ACADEMY COMPLEX RENOVATIONS

PROJECT NO. 2025-016

ADDENDUM 1

July 23rd, 2025

SHEET NO:
L102

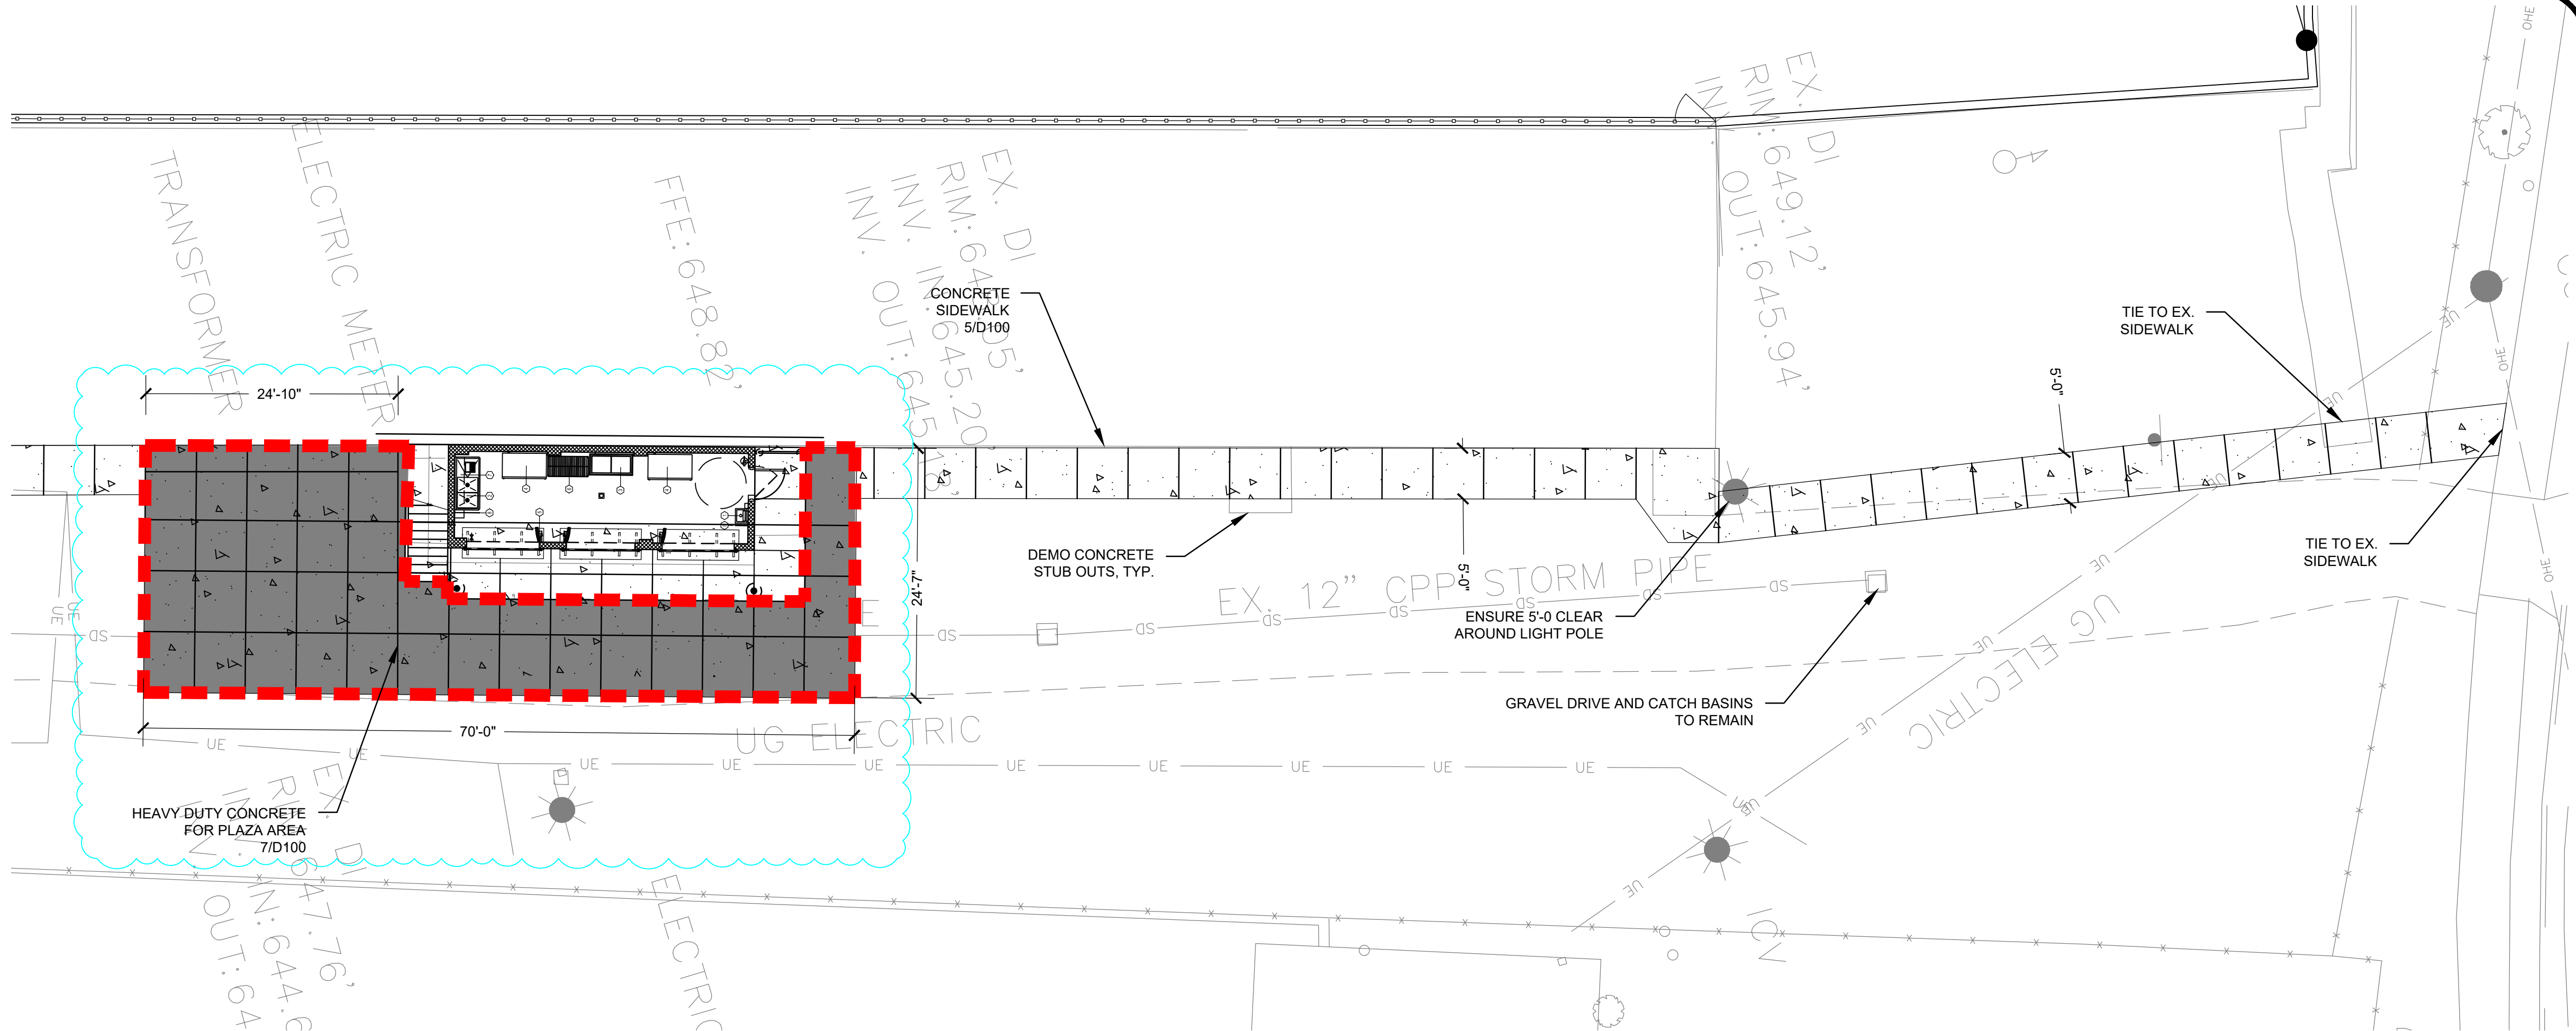
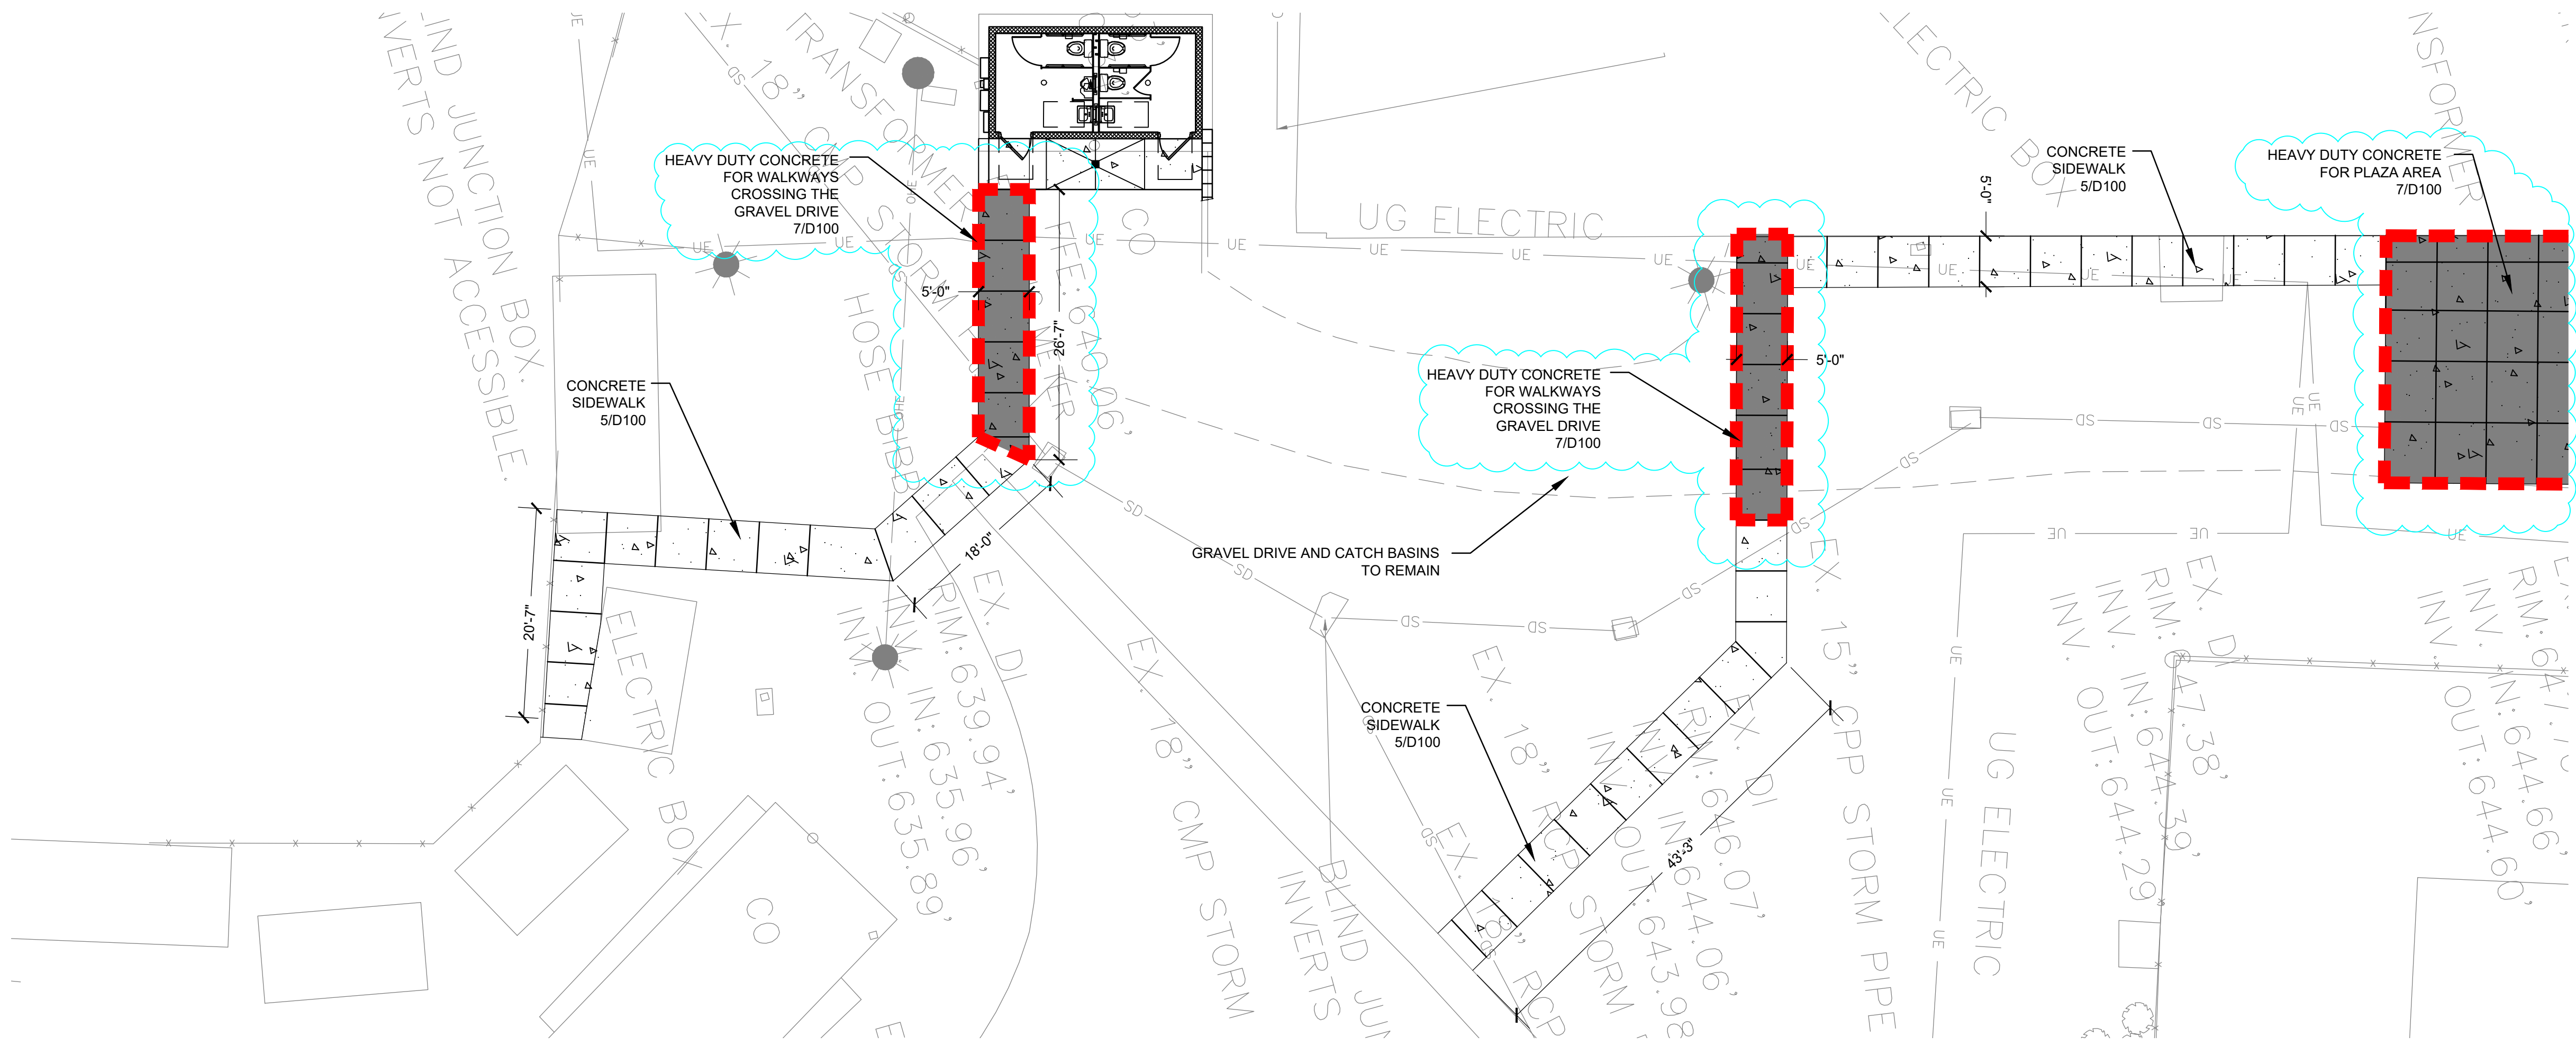
- a. Used at Football Concession. See A1.2 Equipment Schedule - #1 Hand Sink.
- 9. Can you highlight or better label where the HD concrete paving changes to standard sidewalk. We see arrows pointing to general areas, but do not see a clear line or distinction in the hatching pattern that shows exactly where HD concrete paving starts and stops.

- a. Please see the updated L100 and L102 sheets attached.
- 10. Page A1.4 shows an area drain at the exterior of the McAlister Restroom floor plan. It references the site drawings for the drain
